PERMIT NO. **RM#24-00029**

VILLA 9
COMPLIANCE PACKAGE "A1"

BASEMENT PLAN 'I'

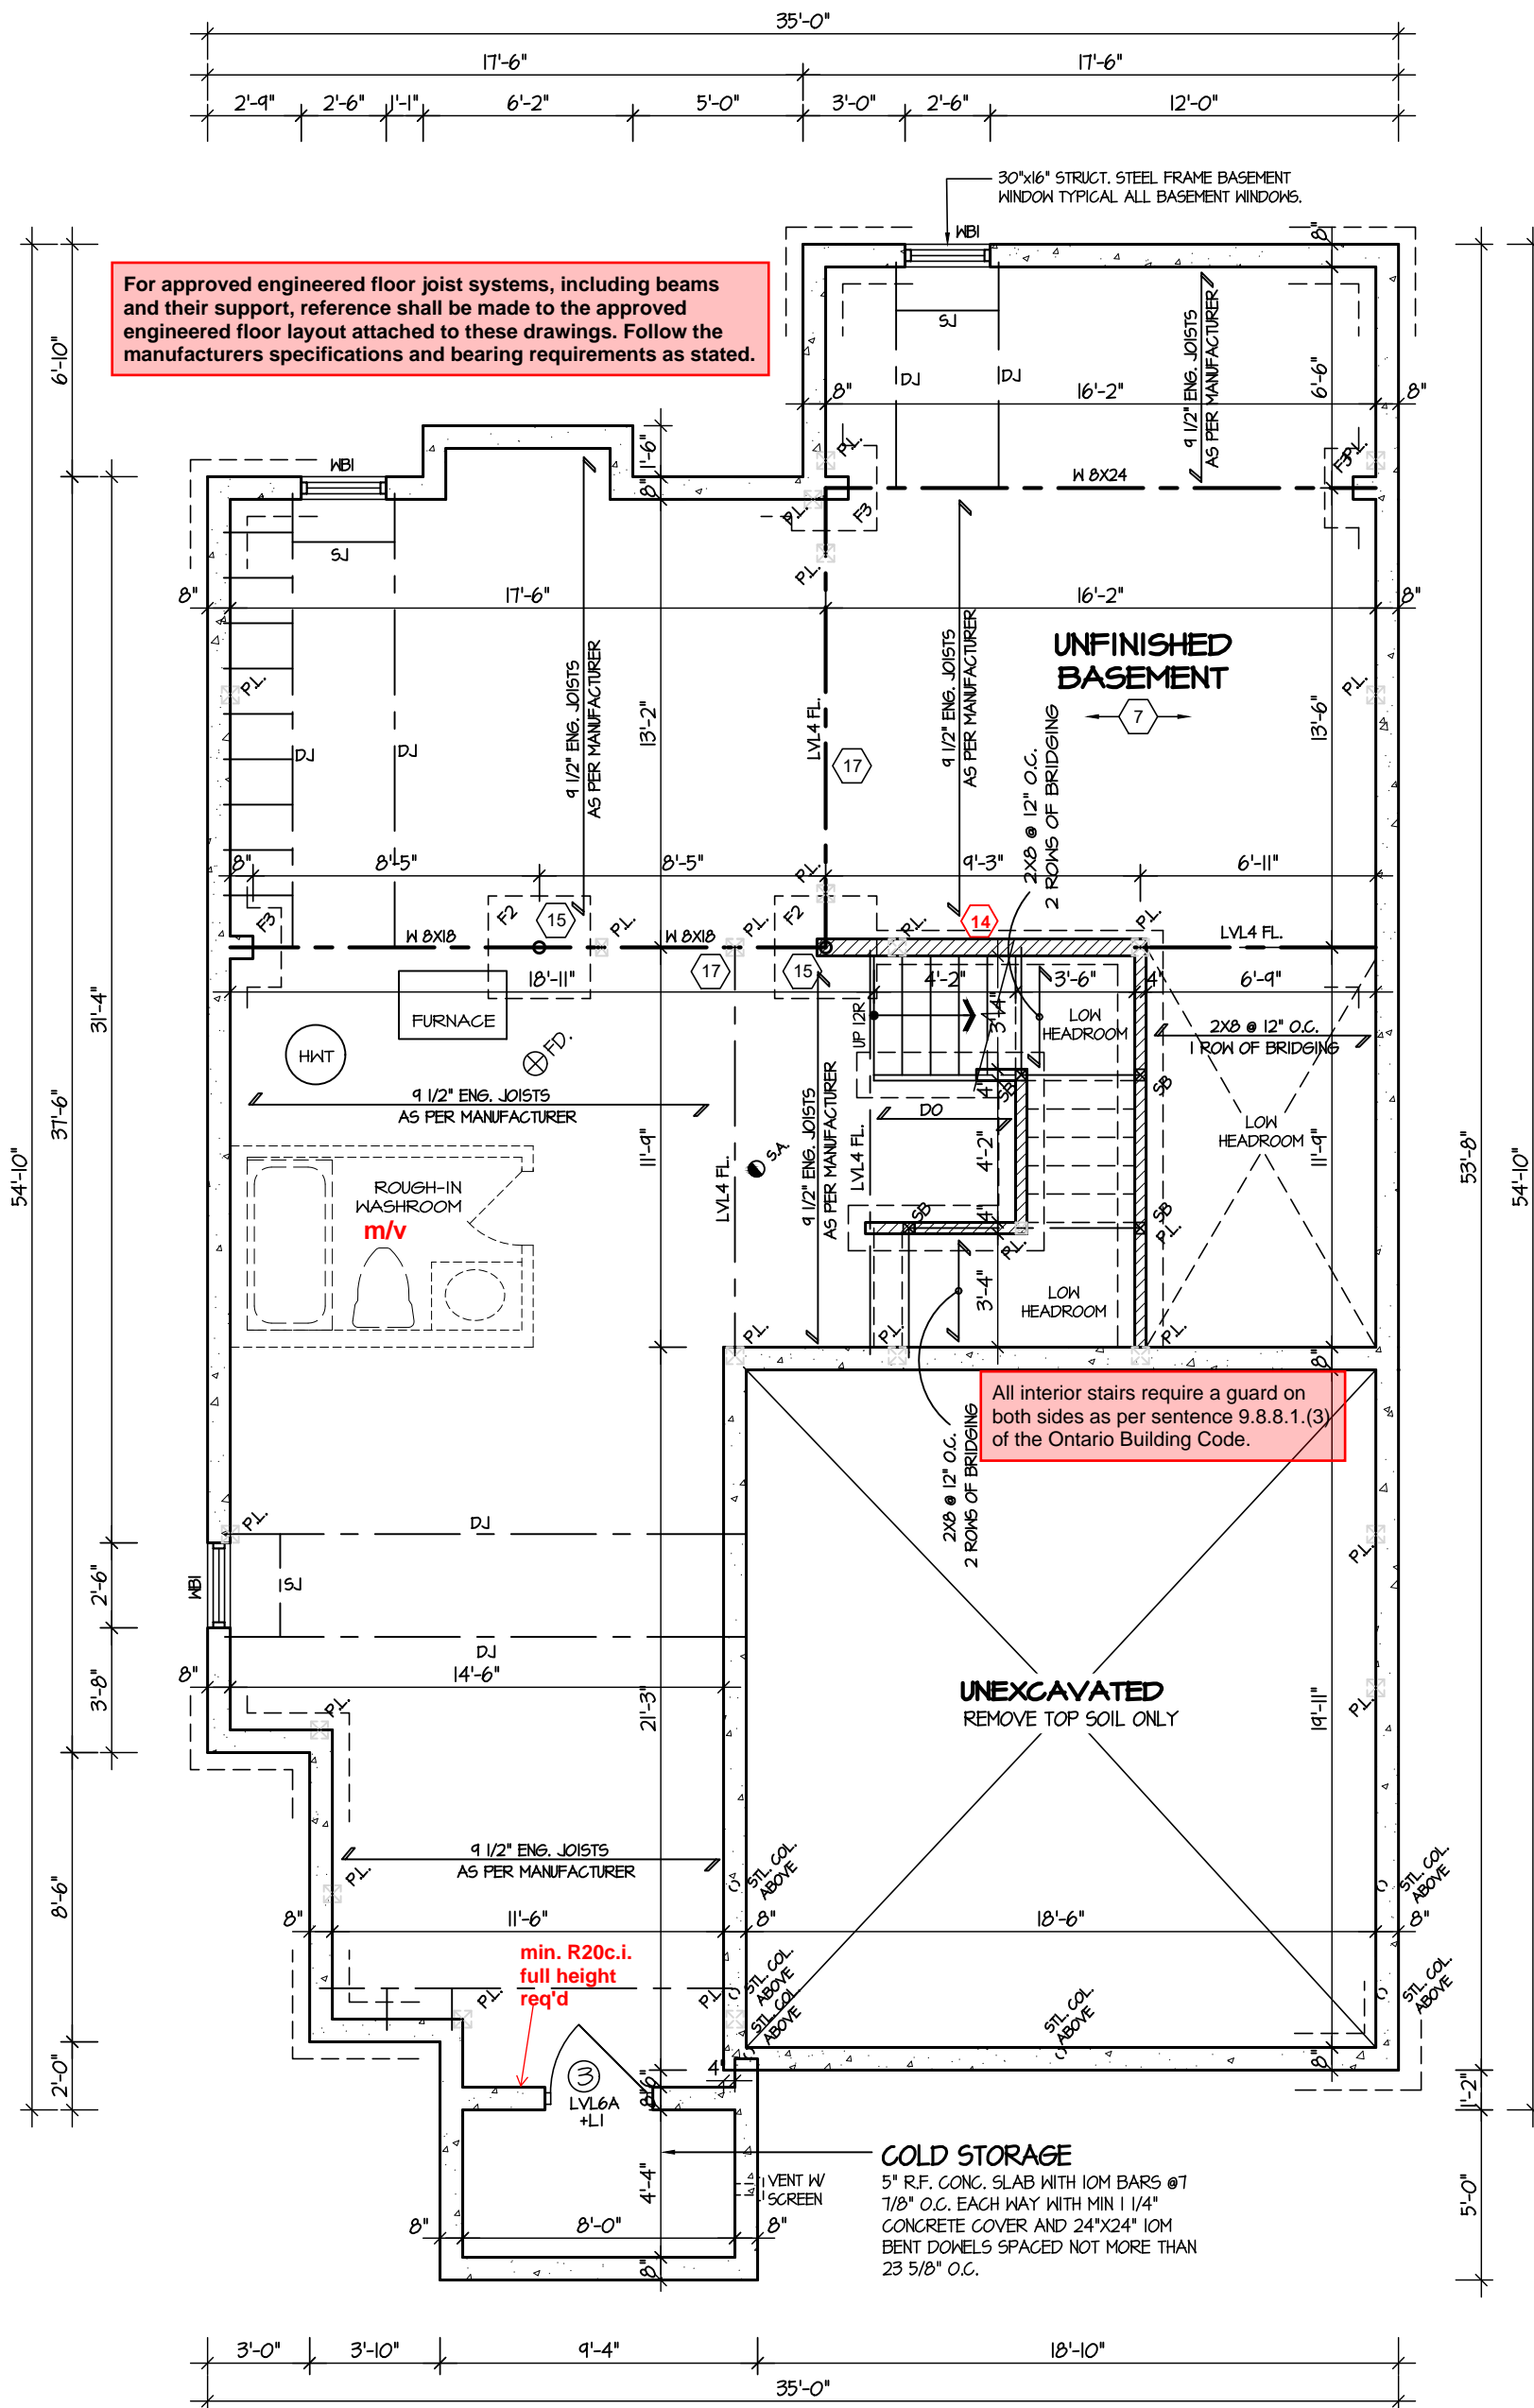
All interior stairs require a guard on both sides as per sentence 9.8.8.1.(3) of the Ontario Building Code.

COLD STORAGE
5" R.F. CONC. SLAB WITH 10M BARS @ 7 1/8" O.C. EACH WAY WITH MIN 1 1/4" CONCRETE COVER AND 24"x24" 10M BENT DOVELS SPACED NOT MORE THAN 23 5/8" O.C.

LEFT SIDE ELEVATION I

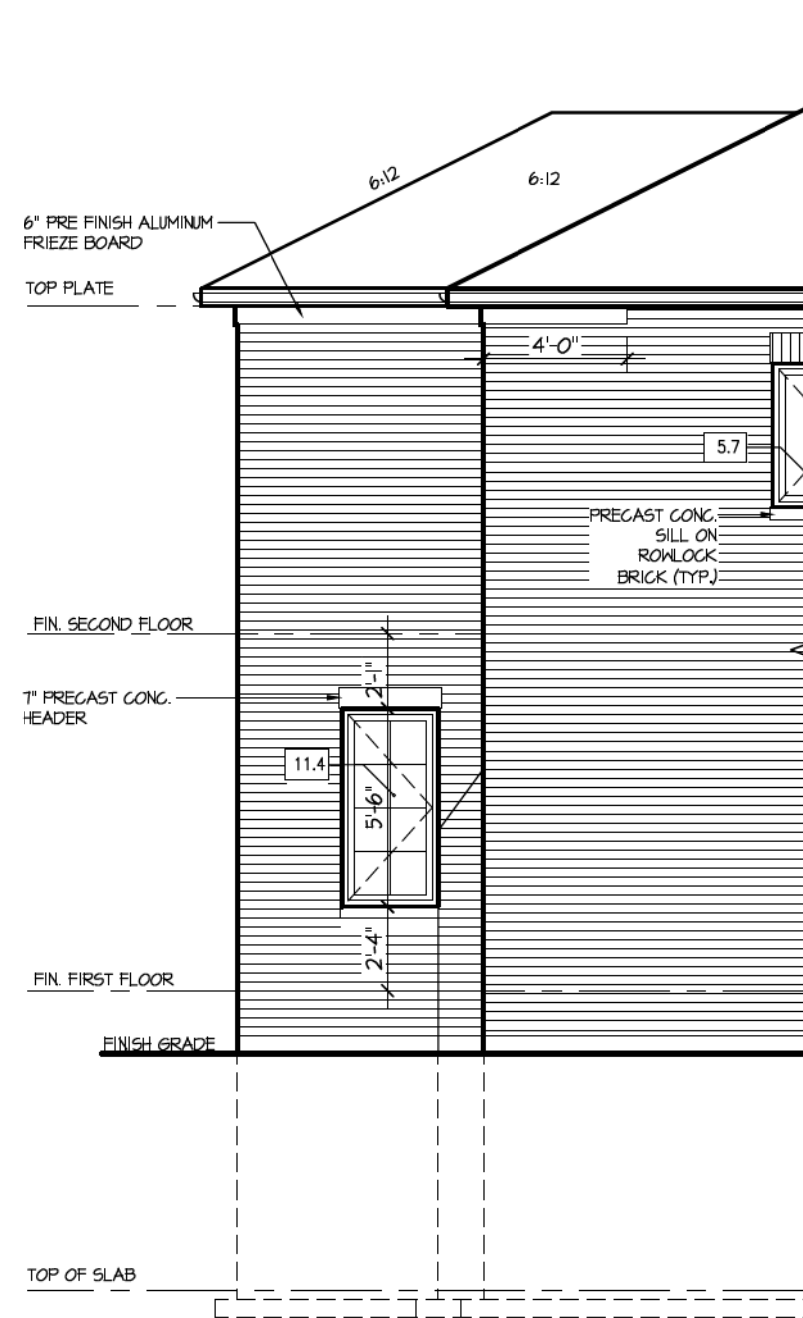
No unprotected openings permitted within 1.2 metres of the lot line as per 9.10.14 of the Ontario Building Code.

RIGHT SIDE ELEVATION I

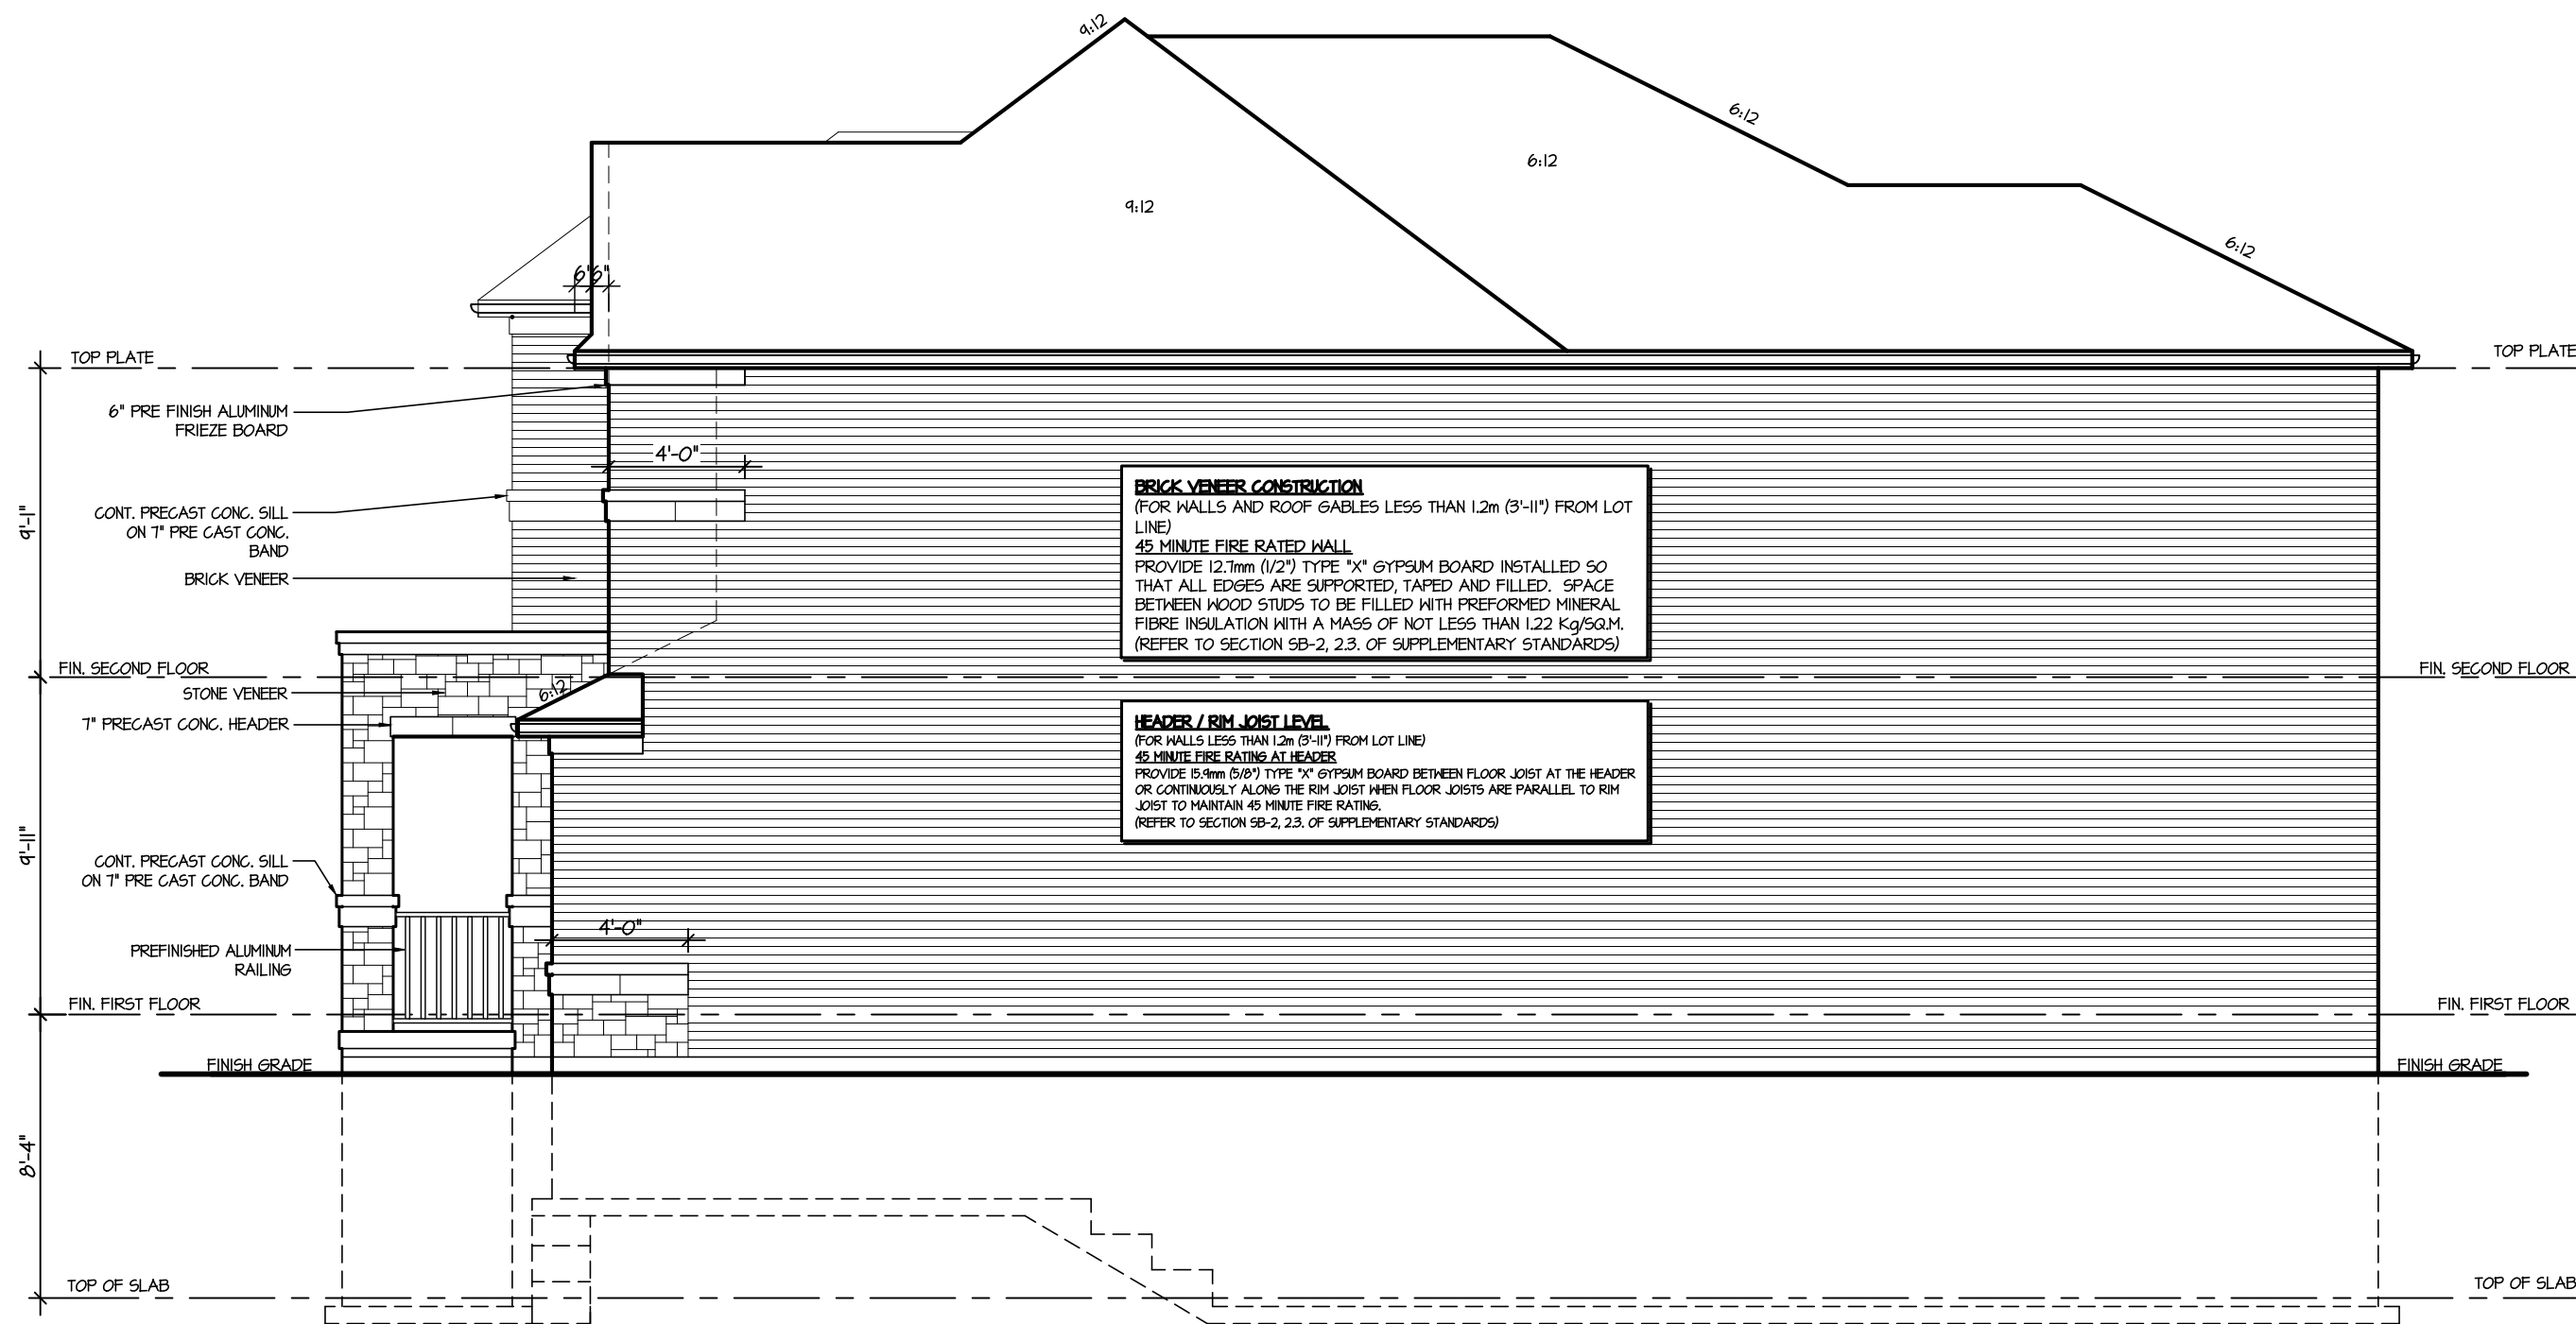
No unprotected openings permitted within 1.2 metres of the lot line as per 9.10.14 of the Ontario Building Code.
